Intel® Desktop Board D850EMV2 Specification Update

Release Date: November 2003

Order Number: A96647-008

The Intel® Desktop Board D850EMV2 may contain design defects or errors known as errata, which may cause the product to deviate from published specifications. Current characterized errata are documented in this Specification Update.

Figure 8. Audio Subsystem Block Diagram

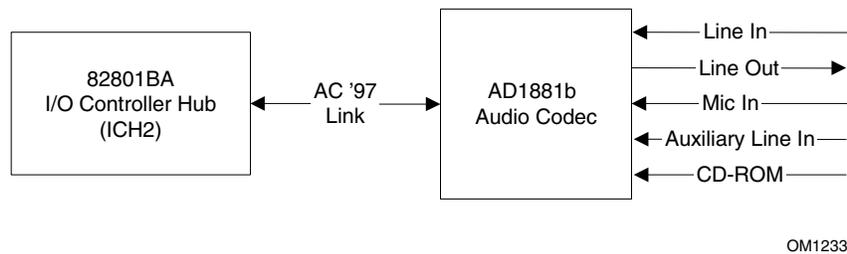
4. Addition to Description of Section 1.10, Audio Subsystem

Section 1.10.1, Audio Subsystem for D850EMVR will be added:

Figure 8 is a block diagram of the audio subsystem.

1.10.1 Audio Subsystem for D850EMVR

The audio subsystem consists of the following devices:

- Intel® 82801BA ICH2
- Analog Devices AD1881b analog codec

The audio subsystem includes these features:

- Split digital/analog architecture for improved signal-to-noise (S/N) ratio: ≥ 85 dB
- Power management support for ACPI 1.0 (driver dependant)
- 3-D stereo enhancement

The audio subsystem supports the following audio interfaces:

- ATAPI-style connectors:
 - CD-ROM
 - Auxiliary line in

- Front panel audio connector, including pins for:
 - Line out
 - Mic in
- Back panel audio connectors:
 - Line out
 - Line in
 - Mic in
 - 1/8" stereo microphone back panel jack
